**AIP SUPPLEMENT
(SUP)****AIRAC****H186/25****Effective: 202511261600 UTC**

WILKINS RUNWAY (YWKS) REVISED PROCEDURES

- 1.1 This AIP SUP replaces SUP H173/25 with changes to the PAPI eye height published in Appendix 1.
- 1.2 This AIP SUP amends the RNP RWY 09T Instrument Approach Procedure and aerodrome chart at Wilkins Runway due to apron and runway data changes.
- 1.3 New RNP APCH waypoints have been designed, to ensure continued alignment with the new RWY position.

AERODROME CHART
WILKINS RUNWAY, ANTARCTICA (YWKS)

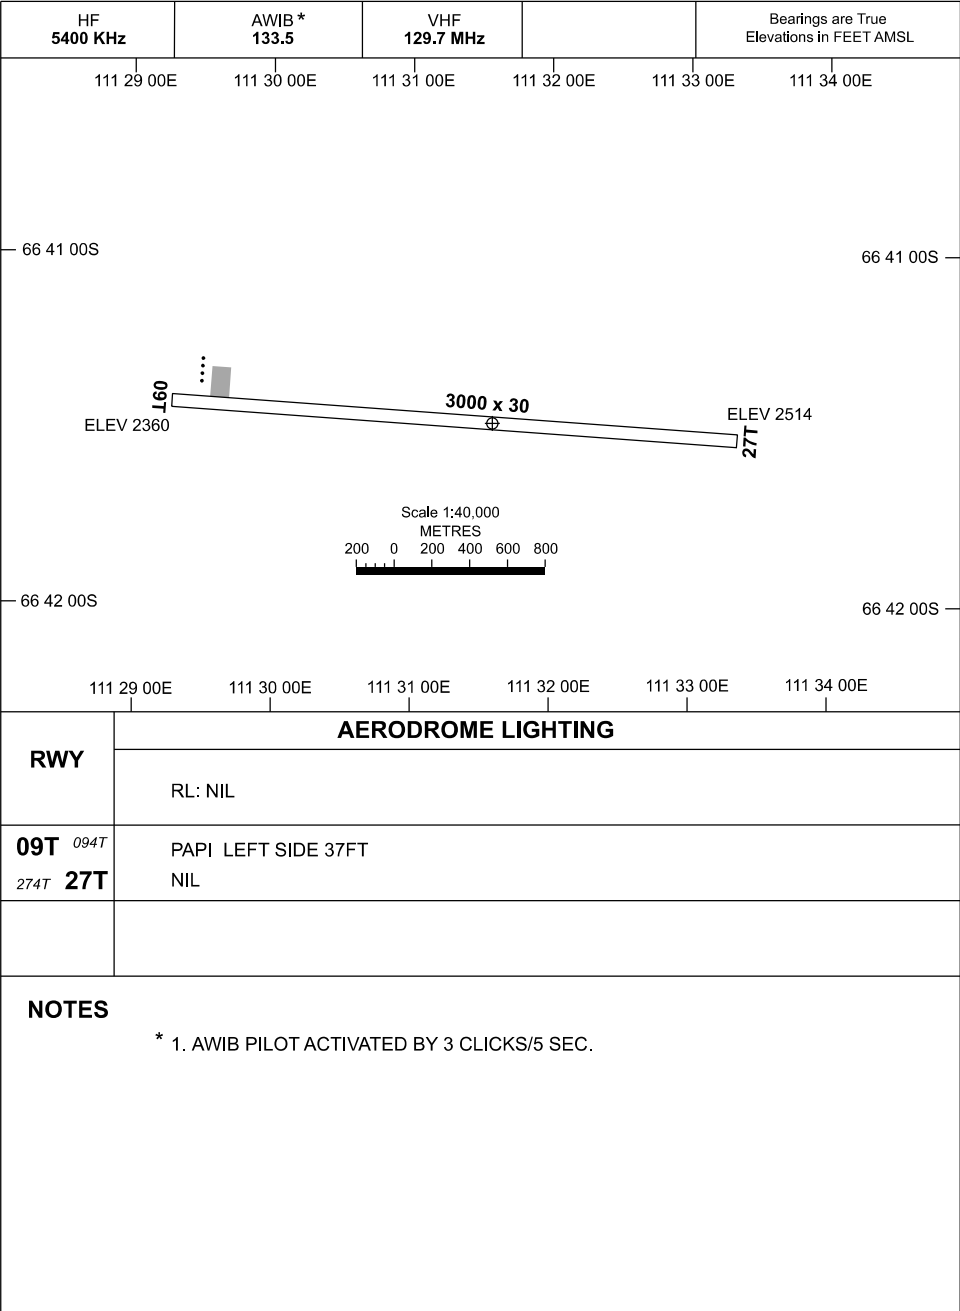
3.1 Amended aerodrome data:

ARP/Threshold	Latitude	Longitude	Elevation
ARP/AD ELEV	664129.02S	1113134.86E	2522 FT
RWY 09T	664125.46S	1112916.55E	2360 FT
RWY 27T	664131.72S	1113320.64E	2514 FT

RNP RWY 09T

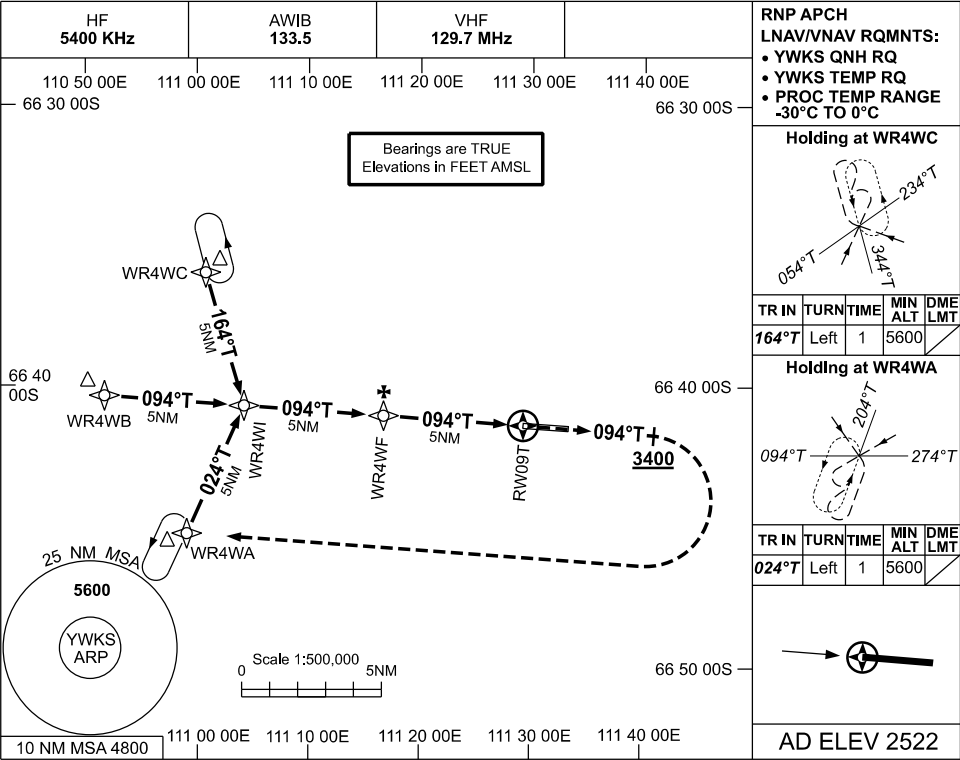
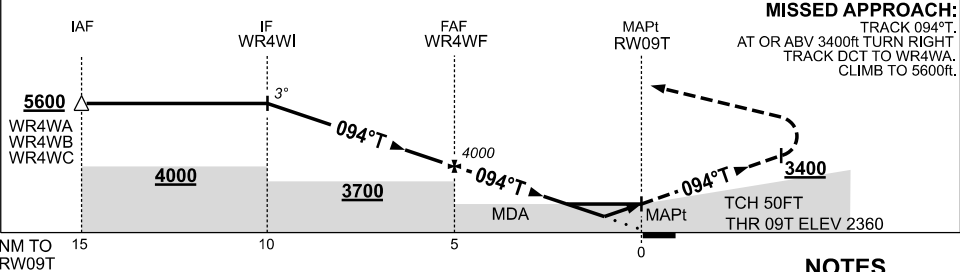
- 2.1 New waypoints for the amended RNP RWY 09T:

- 2.2 The following waypoints are no longer in use from the effective date of this SUP: WR3WA, WR3WB, WR3WC, WR3WI, WR3WF.
- 2.3 Recommended coding is available on request.

Changes: REVISED PROC, AD ELEV, THR ELEV.

Name	LAT	LONG
WR4WA	664517.23S	1105901.92E
WR4WB	664022.50S	1105138.97E
WR4WC	663559.92S	1110045.43E
WR4WI	664044.48S	1110411.14E
WR4WF	664105.47S	1111643.67E
